## **DETAILED ACTION**

fig - 3

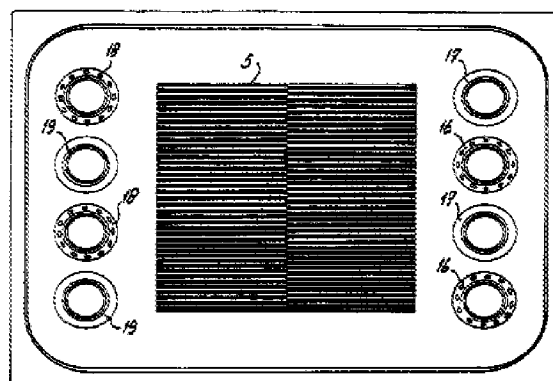
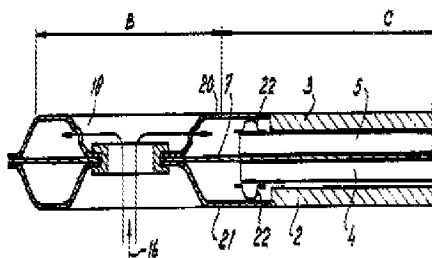
EP'104 discloses a fuel cell stack including a set of fuel cell units comprising a set of electrodes and separator plates (acting as the bipolar plates) for separating the fuel cell units (Col 1, lines 3-8; CLAIM 1; FIGURES 2 and 8). The fuel cell has separator plates 7 with a corrugated central portion 5 and gas supplying and exiting openings on flat edges held between an upper and lower partitioning plate with corresponding openings, the partitioning plates 20, 21 being provided with a transfer region between the flat partitioning plates and the separator plate, the connection between the transfer regions and the separator plate comprising a circumferential connection around said openings (CLAIM 1). **FIGURES 3-4** below show a plate and an arrangement including the electrochemically active area of the fuel cell unit in conjunction with the plates and the openings for conducting media; and a bead arrangement including a region, part, area or side thereof having a perforation for conducting media.

*In this case, the separator plates represent bipolar plates; and the flank is taken to be represented by ANY part of the bead side either to the right or left (or any structural orientation) of the formed bead or the area along either side thereof. Note that the present claims fail to define the specific structure of the flank with respect to structural arrangement or spatial orientation. Note that the stacking of the fuel cell elements does produce sufficient compression in the stacking direction.*

It can be appreciated from viewing **FIGURES 3-4** that the openings include circular and/or angular openings.
